Technical Service Bulletin

Technical Service Bulletin: TSB170022	Released Date: 10-Oct-2019
Steel Piston and Aluminum Piston Kit Introduction

Figure 1, Steel Piston Authorized Change Label.

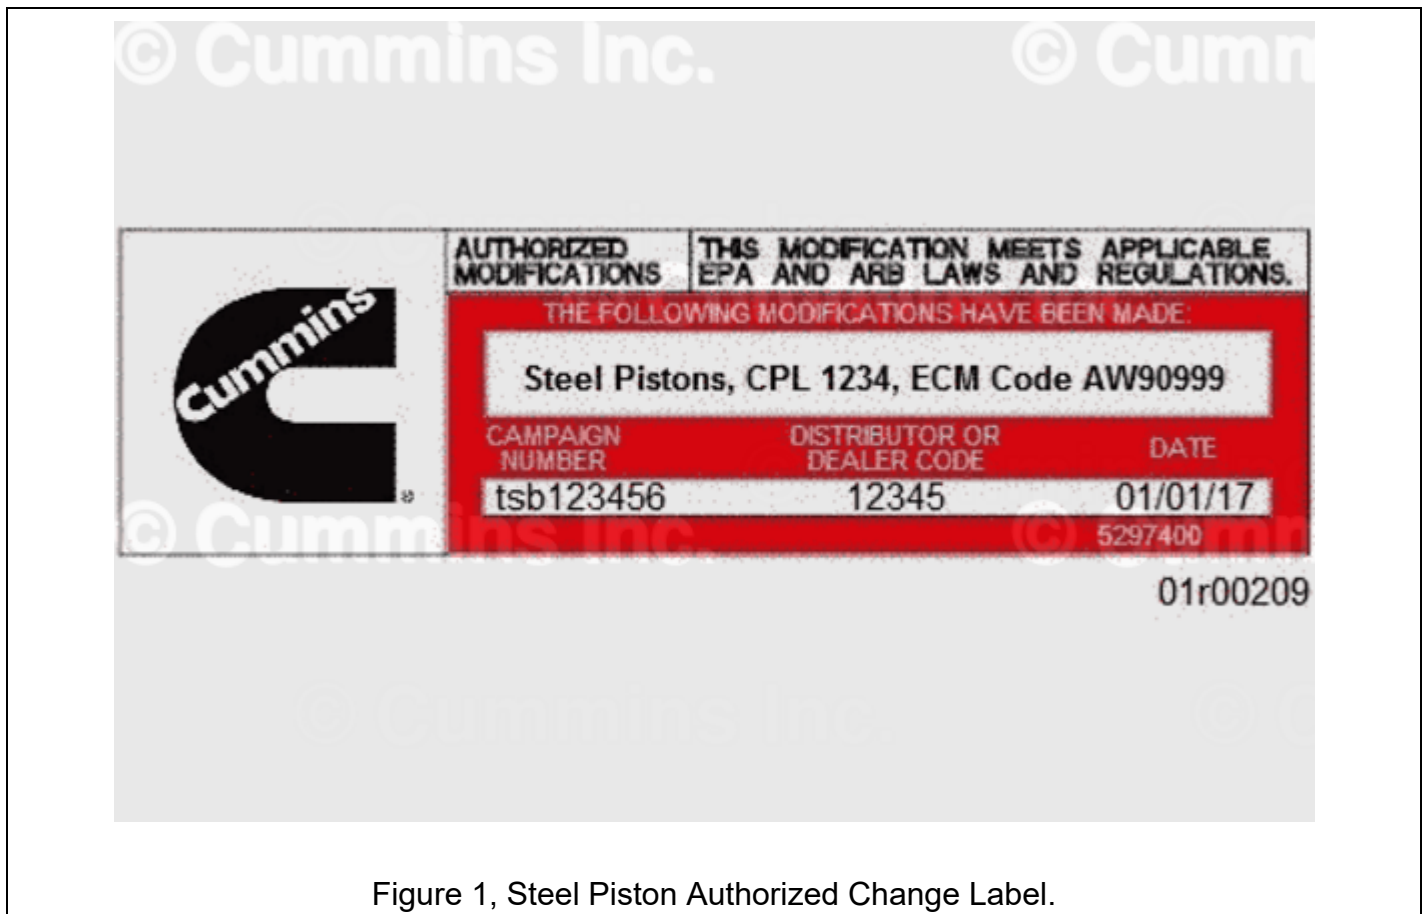
- When changing from aluminum to steel pistons, the CPL number will change.
- Upon completion of the conversion from aluminum to steel pistons, an authorized change label, Part Number 5297400 **must** be completed and installed on the engine. See Figure 1 below.
